Docket Item # 9
BAR CASE # 2009-0173

BAR Meeting
September 2, 2009

ISSUE: Alterations to previously approved plans
APPLICANT: Judith and Tushar Suthar by Stephanie Dimond
LOCATION: 833 South Fairfax Street
ZONE: RM/Residential

Figure 4. Proposed revised floorplans.

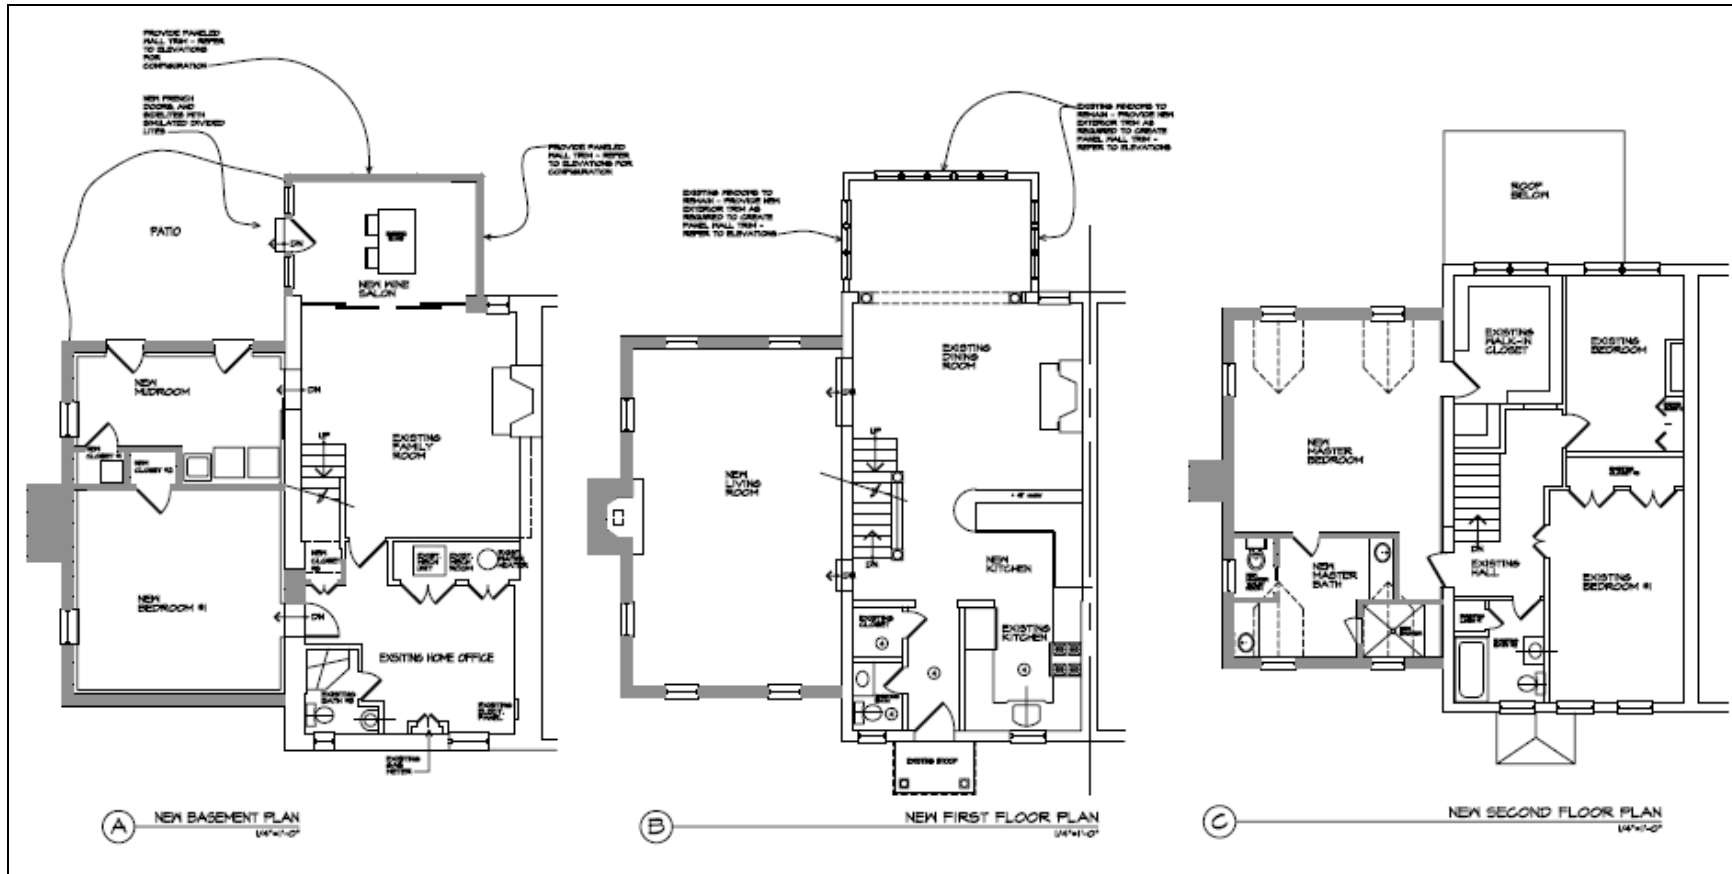
Three of the proposed changes to previously approved plans regard the treatment of the first story on the existing rear two-story addition. On the north and west elevations, the applicant proposes to change what were fixed louvered shutters and what were multi-light casement windows flanked by single panels, respectively, to solid panels. The revised design will have three panels on the north elevation and seven panels on the west

The north elevation is not visible from the public right-of-way. While Staff finds that the original design, with fixed shutters, was more appropriate and related to the appearance of this addition as an enclosed porch, Staff notes that any changes to this elevation will have a minimal impact. However, the west elevation is visible from Green Street. Staff finds that approximately the upper third of the first floor will be visible from Green Street. The change from casement windows to plain panels represents a dilution of the original design. The *Design Guidelines* state that “the design of an addition should respect the heritage of the historic building to which it is attached as well as adjacent buildings...or which echo the design elements of the existing structure.” Recognizing that the elimination of the windows on this elevation is to accommodate the interior program, Staff finds that the most appropriate solution is to use fixed louvered shutters to replace what had originally been proposed casement windows. Such a revision will allow the addition to continue to read as an enclosed two-story porch. The shutters originally proposed for the north elevation are recommended for the revised west elevation. Staff would support the use of a composite wood shutter in this location.

1. That fixed shutters be used on the first story of the enclosed porch rear addition rather than the proposed panels (the shutters may be a composite wood material, to be approved by Staff); and
2. That if a synthetic material is used on the enclosed porch rear addition, that the material be solid-through-the-core and paintable, with final approval by Staff.

Figure 6. Proposed window specifications.

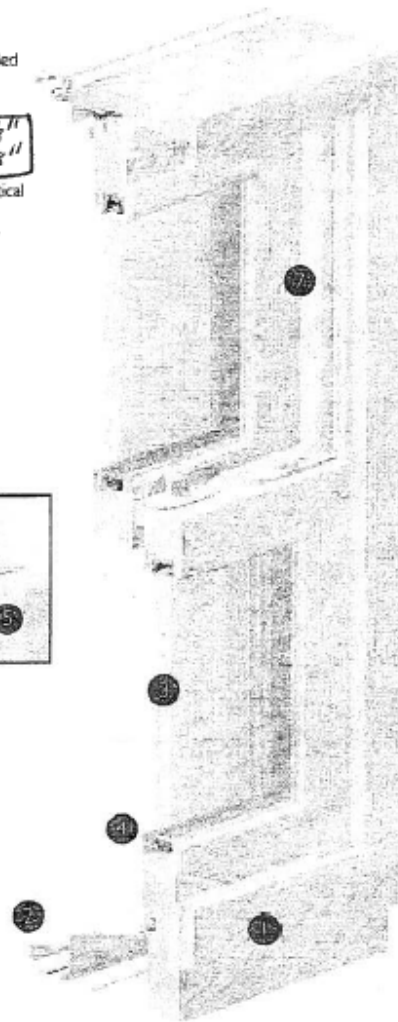
The *Design Guidelines* recommend that: “...replacement windows should be appropriate to the historic period of the architectural style of the building.” The *Guidelines* also state that single-glazed, true divided light windows with interior storm sash are the preferred replacement window type. The *Guidelines* continue by saying other acceptable window types are “double-glazed true divided light wood windows...Windows with fixed or applied muntins have been approved for the rear elevation of a structure which has minimal visibility from a public right of way.” In many cases, the Board has approved simulated divided light, double-glazed wood windows for additions as well as for replacement windows for townhouses of similar vintage. In this particular case, had the applicant originally proposed simulated divided light, double-glazed wood windows, Staff would have recommended approval. Staff again finds that the proposed simulated divided light with interior spacer bar and exterior applied muntins, double-glazed, wood windows are acceptable and recommends approval as submitted.
